MINERALS PROGRAM INSPECTION REPORT
PHONE: (303) 866-3567

MINE NAME: Riverview Resource	MINE/PROSPECTING ID#: M-1999-098	MINERAL: Sand and gravel	COUNTY: Weld
INSPECTION TYPE: Monitoring	WEATHER: Raining	INSP. DATE: June 30, 2023	INSP. TIME: 11:00
OPERATOR: Holcim - WCR, Inc.	OPERATOR REPRESENTATIVE: None	TYPE OF OPERATION: 112c - Construction Regular Operation	
REASON FOR INSPECTION: Normal I&E Program	BOND CALCULATION TYPE: Partial Bond	BOND AMOUNT: \$11,300,000.00	
DATE OF COMPLAINT: NA	POST INSP. CONTACTS: None	JOINT INSP. AGENCY: None	
INSPECTOR(S): Peter Hays	INSPECTOR'S SIGNATURE: 	SIGNATURE DATE: July 6, 2023

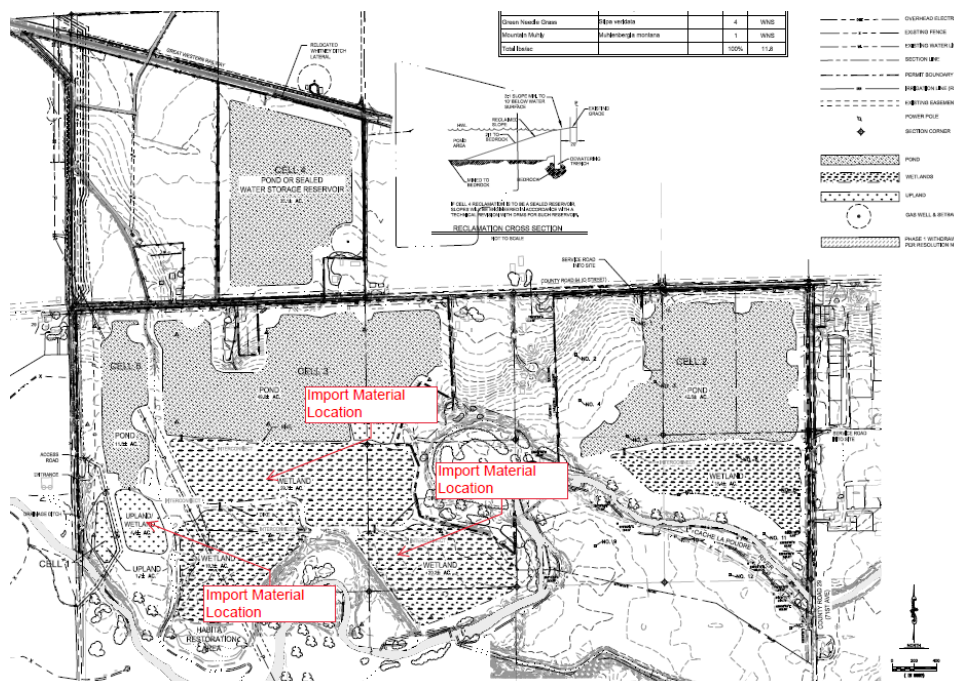
The Operator submitted technical revision no. 3 (TR3) on June 29, 2023. The technical revision proposes to import inert fill to backfill the southern portions of Cell 3 and Cell 5. A copy of the map submitted with TR3 is inserted below for reference. The Division is required by Rule 1.9 to act on a technical revision within thirty (30) days after being filed with the Division.

The Operator previously stated, the post-mining land use would be revised from open-water lakes and wetland in Cells 1, 3 and 5 to rangeland by backfilling all of the exposed groundwater in the cells with inert fill.

The Division considers a change in the post-mining land use a significant revision to the approved Reclamation Plan. Pursuant to Rule 1.1(6), an "Amendment" means a change in the permit or an application which increases the acreage of the affected land, or which has a significant effect upon the approved or proposed Mining Plan or Reclamation Plan. The Division will require the Operator to submit an amendment application to revise the post-mining land use from wildlife habitat to rangeland with developed water resources.
